From: Griffin, Tim
Sent: 22 January 2024 21:15
To: Harrison, Liz
Cc: Dyer, Tim
Subject: F/23/96629 Land at Fieldfare Road, adjacent to the roundabout with Winchester Road - landscape comments

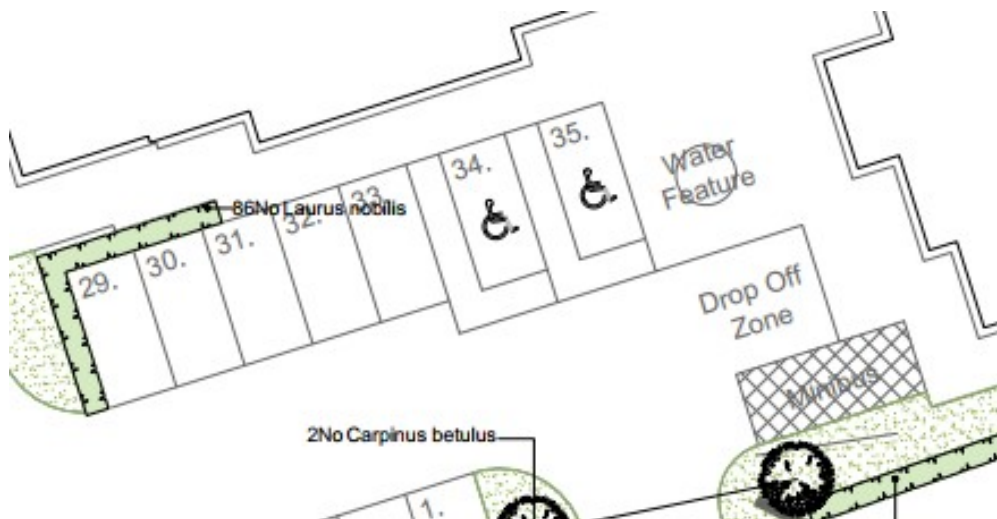
The site is in a very prominent position at the entrance to a major new residential development. The proposed Care Home will be a dominant element in the streetscene with open views from both Winchester Road and Fieldfare Road. The scale and massing of the proposed 3 storey building means the proposal will be immediately apparent to the observer. To balance and soften the visual impact of the Care Home a robust and continuous landscape buffer is essential to ensure views of the facility are effectively softened. At present sections of the building project too close to the frontages along Winchester Road and Fieldfare Roads. This creates pinch points in the areas available for planting which results in the planted screen being disrupted.

The present site layout shows that the proposed building footprint, footpaths and drives/parking occupy more than 50% of the site area. The remnant areas of soft landscape are rather disjointed in form, with some being narrow slithers of land.

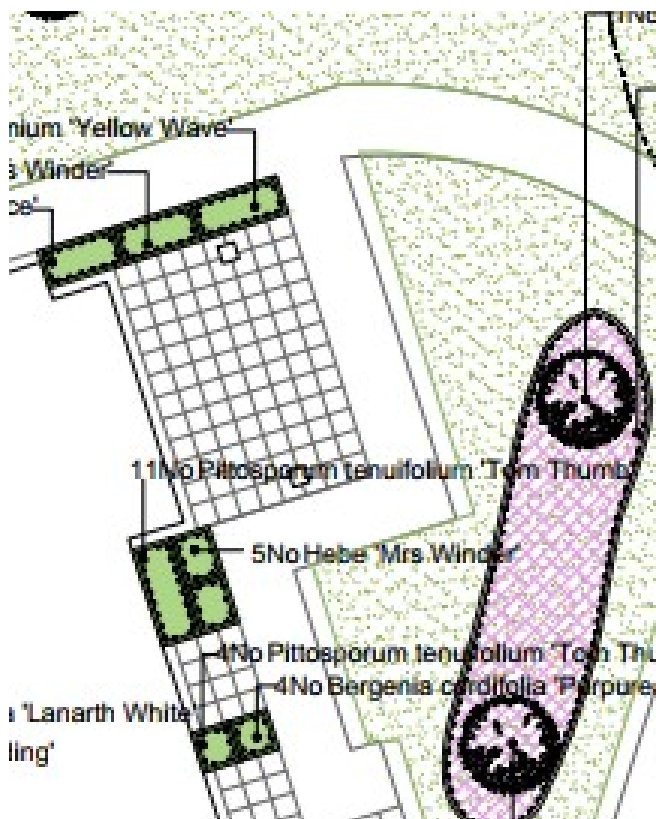
3/ In my view the present landscape proposals are rather basic and there is scope to significantly uplift the quality of design in a number of locations.

This focal area could certainly benefit from a more imaginative approach creating a space that is not only pleasant to pass through but also bearing in mind views for residents from above:

The resin bound circulation path follows tight to the building and perhaps there is scope to extend this into the NE corner to make more of this external space and to provide a longer and more varied route for the path. At present the path is not continuous around the building and this should be rectified to create a linked route.

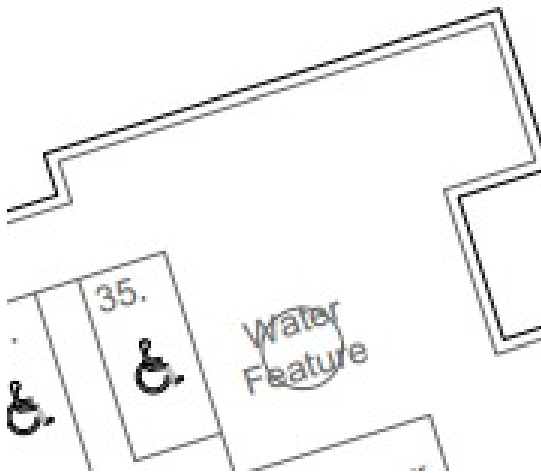
The arrivals area is very disappointing with a notional water feature shown surrounded by a bland area of resin bound surfacing. This is a key arrivals area and needs to be redesigned to create a pleasant focal space.

4/ ACD Hard Landscape Proposals

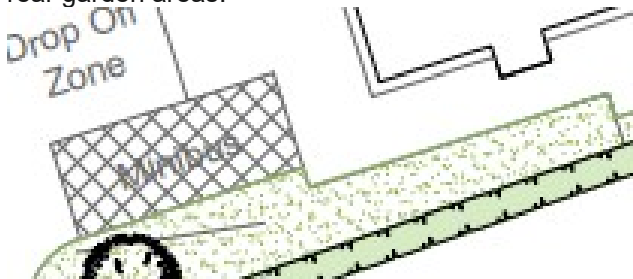
The legend notes incorrectly that the resin bound gravel is used on driveway/parking bays. It is shown on plan for the pedestrian path around the building. Please correct.

There is a short section of path not toned in correctly.

As mentioned above, can the path be made continuous around the whole length of the building to create a linked route?
